# Access Compliance Report

## Public Rights-of-Way

Intersection ID: N/A	Main Street: WAVERLY_WALK_AV	Cross Street: HONEYMEADE_CIR	Location: NW
ADA ID: 5228D4119EDB	Ramp Type: Perp	Initial Pass/Fail: Fail	Overall Compliance: No
Severity Score: 1.25			
Codes/Mitigation Info/Possible Solution		Field Measurements/Component Compliance

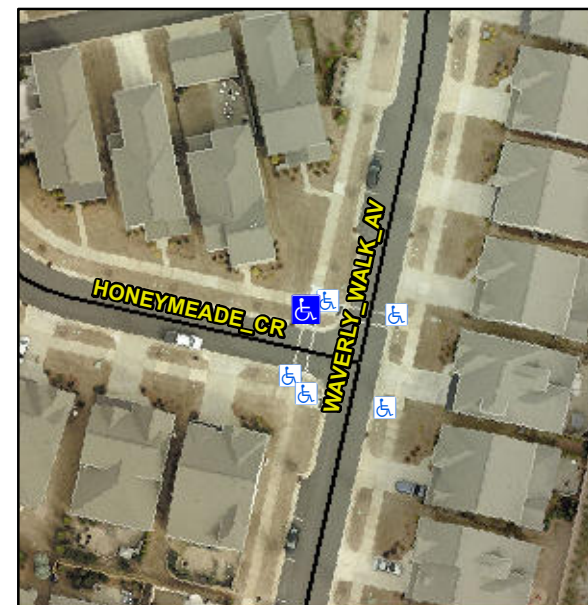
**R304.5.3**

Compliance	Description	Data	Compliance	Description	Data
N/A	Ramp Length (in)	97.0	Yes	Ramp Slope (%)	8.3
Yes	Ramp Width (in)	72.0	No	Ramp XSlope (%)	2.9
N/A	Flare Type LT	N/A	N/A	Flare Type RT	N/A
N/A	Flare Slope LT (%)	N/A	N/A	Flare Slope RT (%)	N/A
N/A	Flare Traversable LT?	N/A	N/A	Flare Traversable RT?	N/A
N/A	Landing Length (in)	N/A	N/A	DWS Provided?	N/A
N/A	Landing Width (in)	N/A	N/A	DWS Contrast?	N/A
N/A	Landing Slope (%)	N/A	N/A	DWS Length (in)	N/A
N/A	Landing X Slope (%)	N/A	N/A	DWS Full Width?	N/A
N/A	Landing Curb? (Y/N)	N/A	N/A	DWS Offset (in)	N/A
N/A	Shared Landing?	N/A			
N/A	Gutter Ponding?	N/A	N/A	Gutter Slope (%)	N/A
N/A	Gutter Lip Ht (in)	N/A	N/A	Gutter X Slope (%)	N/A
N/A	Painted X Walk1?	No	N/A	Painted X Walk2?	N/A
	X Walk 1 Direction	To SW		X Walk 2 Direction	N/A
N/A	X Walk 1 Width (in)	N/A	N/A	X Walk 2 Width (in)	N/A
	X Walk 1 Slope (%)	0.7		X Walk 2 Slope (%)	N/A
	X Walk 1 X Slope (%)	1.4		X Walk 2 X Slope (%)	N/A

**Remove & Replace Entire Ramp.**
